M25 junction 10/A3 Wisley interchange TR010030

5.5 Flood risk assessment

5.5 FLOOD RISK ASSESSMENT

Regulation Number:	Regulation 5(2)(a)
Planning Inspectorate Scheme Reference	TR010030
Application Document Reference	TR010030/APP/5.5
Author:	M25 junction 10/A3 Wisley interchange project team, Highways England

Figure 1: Cross section data

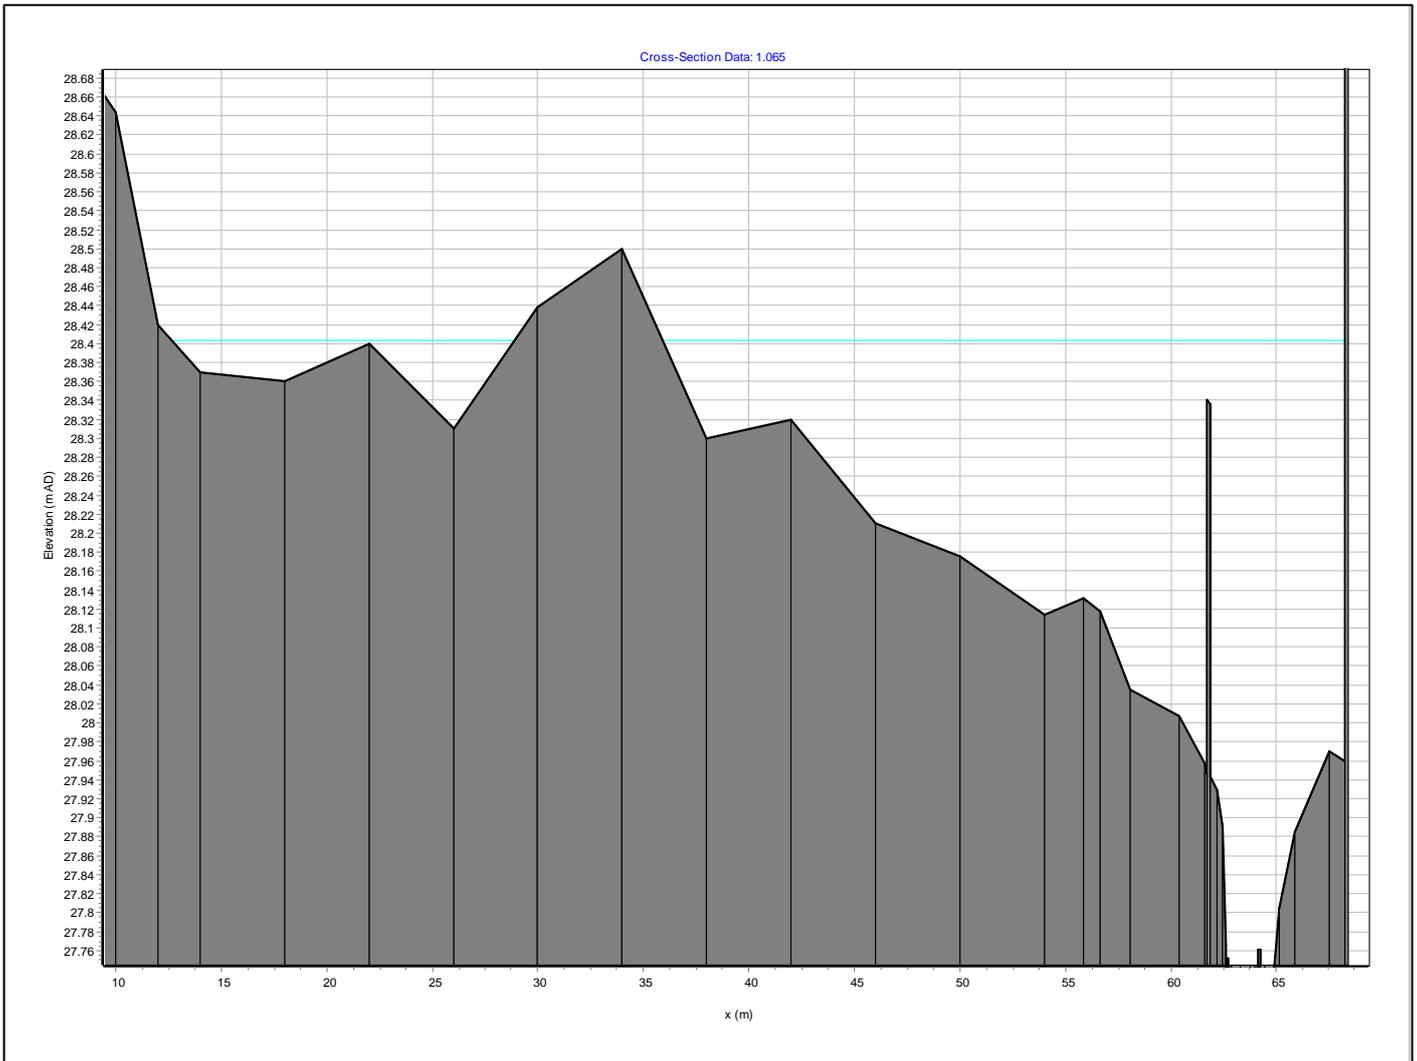
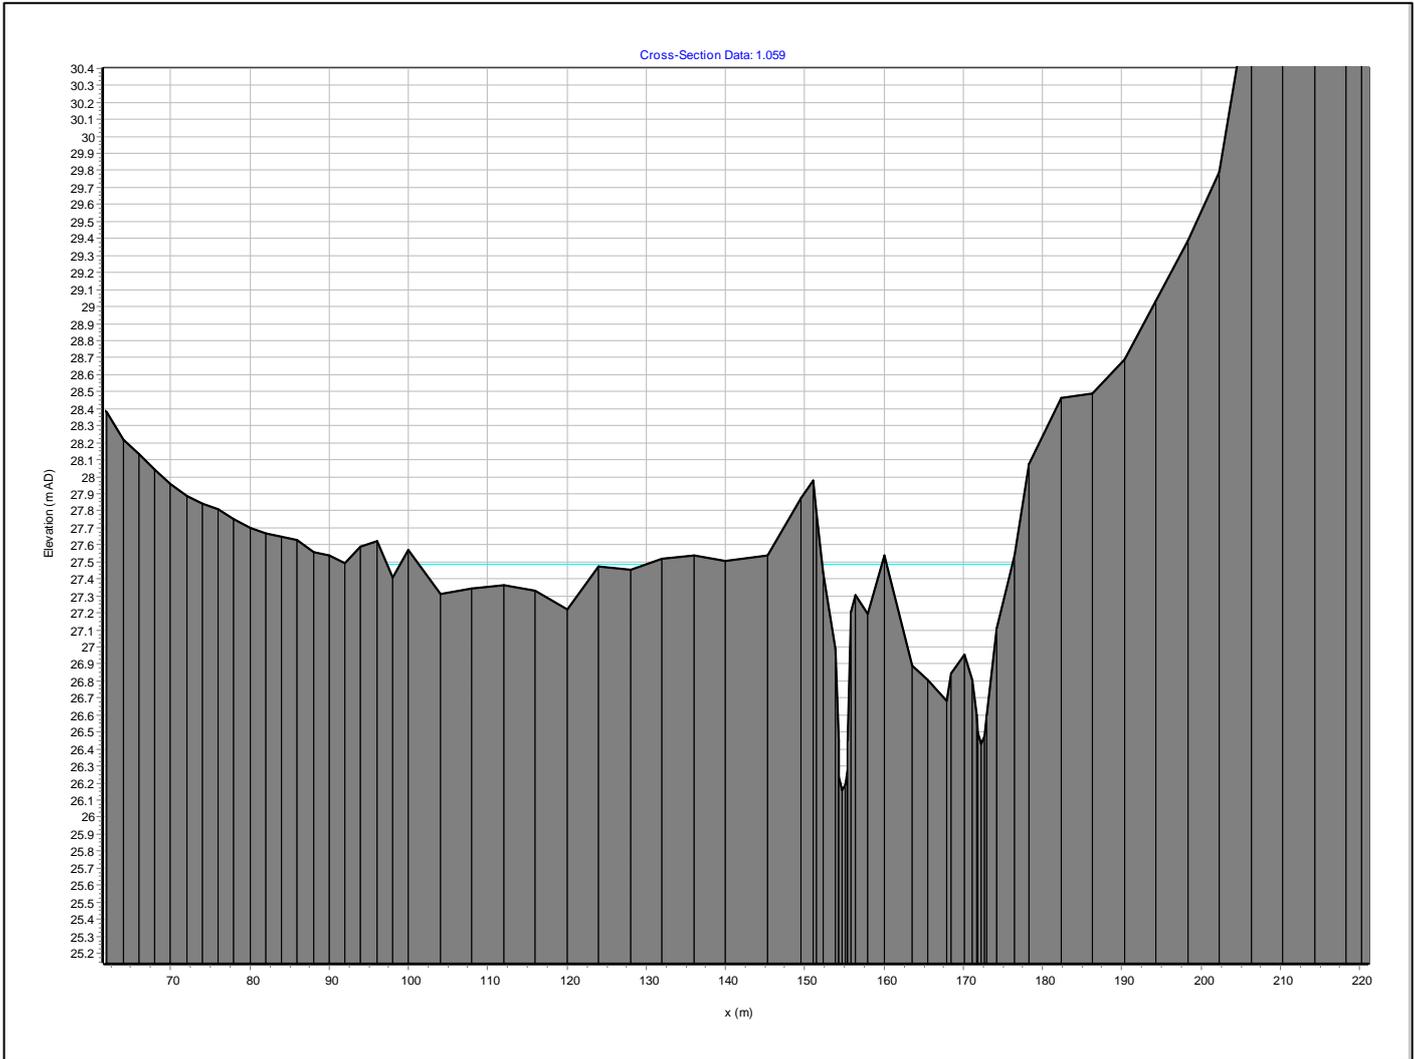
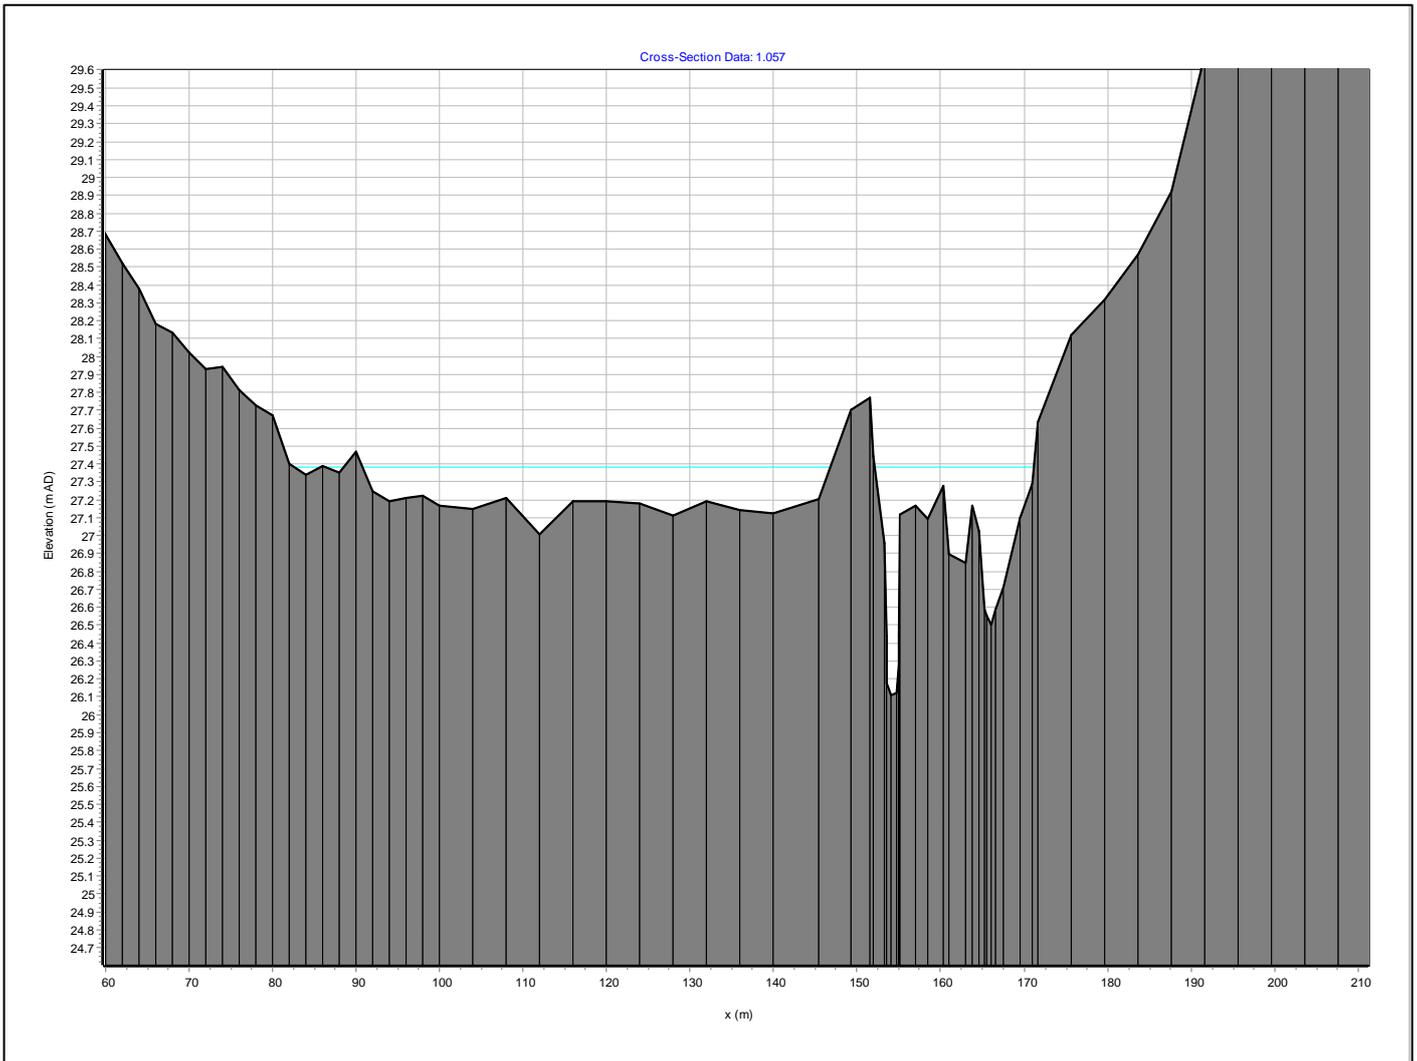
you if necessary.	
Does conveyance look appropriate? <i>Do channel conveyance values vary outside the ratios of 0.7 and 1.4 between adjacent river sections? (Are panel markers needed or in the correct place)</i>	There are massive variances in channel conveyance- the first 7 sections have conveyance values of 18,000, 400, 210, 12,000, 18,000, 35,000 and 240,000m ³ /s. These represent ratios of 0.022, 0.525, 57, 1.5, 1.94 and 6.8 respectively.	Review and amend cross section data to reflect true size of channel.	Values quoted are for conveyance at the maximum cross section elevation which differs significantly between cross sections and therefore comparison of these values is inappropriate. The conveyance at the same relative level within adjacent sections is generally within the usual variation. No updates to the model have been made.	Agreed- however this is not good practise
Bank Markers. Are they used and if so, are they suitably located?	Yes	n/a	n/a	n/a

Figure 4: Extract from Bridge drawing

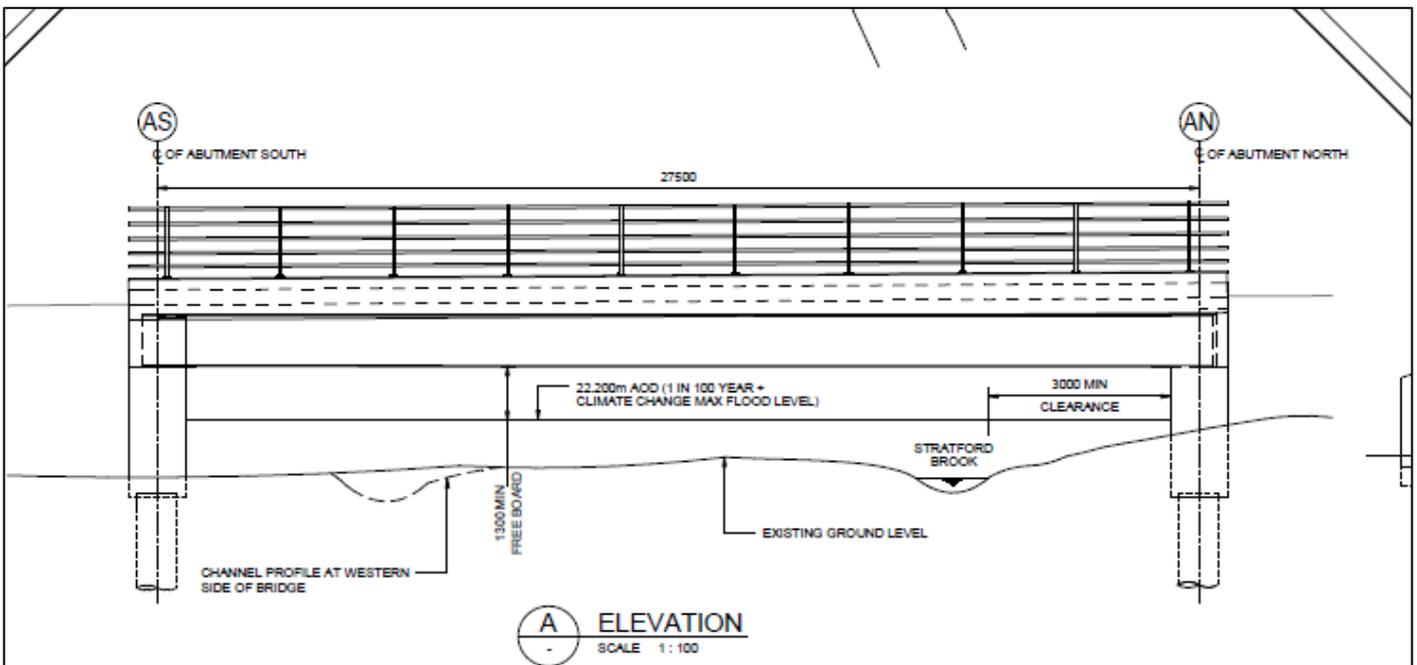
as 22.2mAOD which does not correspond itself to modelled levels extracted from the results. The alignment of the bridge and the channel profile at the bridge should be not well defined between the model data and drawings.		It is not a secondary channel. As labelled on the drawing it is the lateral location of the same channel at the downstream end of the proposed bridge. No changes to the model have been made.	
Are invert levels correct compared to survey data? <i>Check of all critical structures required.</i>	No survey has been provided to check against.	Supply survey to check structures against	The survey data used is as provided by the EA. We can send the survey back to you if necessary.	Noted
Do bridges surcharge? If so has orifice flow been enabled?	Orifice flow is not enabled however the bridges are modelled appropriately with spill units to take surcharging flows.	n/a	n/a	n/a
Are there spills around the structure or over the top represented appropriately? <i>– these could be in 1d or 2D, if a linked model.</i>	No reporting or comments detail the nature of the spill data.	For Bridges where spills are active for the 1:100yr+CC event- report what the spill unit defines or add comment to model.	Report updated to define the use of spill units.	Text added to 2.4.3

Figure 5: Convergence plot from re-run of the 1:100yr+CC simulation

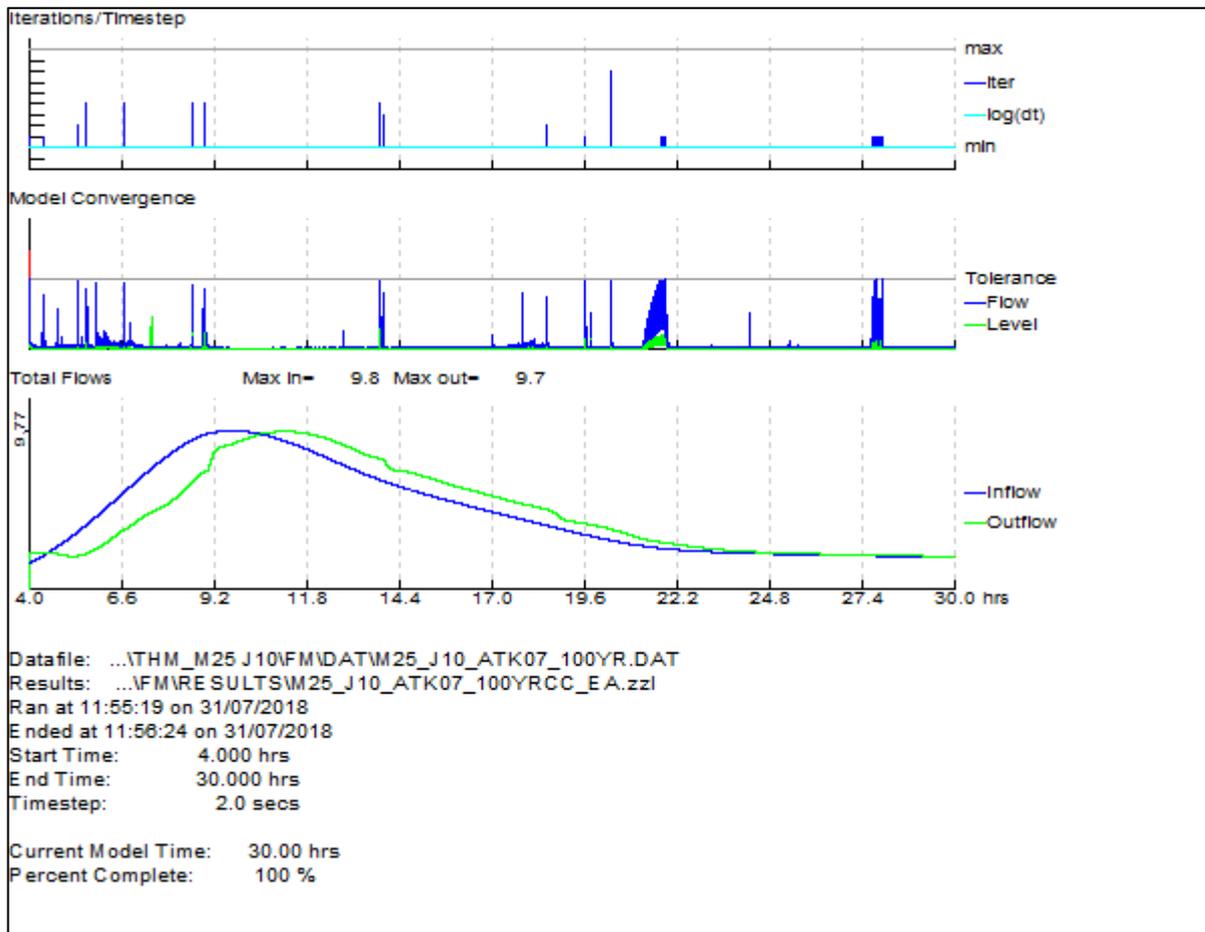
Item Checked	Comments	Actions	Atkins Response	M+F Response
Mass Balance	Mass balance reported in the .ZZD file shows MB is 0.81% of peak system volume, and 0.08% of the boundary inflow volume. These values are fine.	n/a	n/a	n/a
Convergence <i>Check zzd file and bitmaps</i>	Convergence plots look fine (See Figure 5 below)	n/a	n/a	n/a
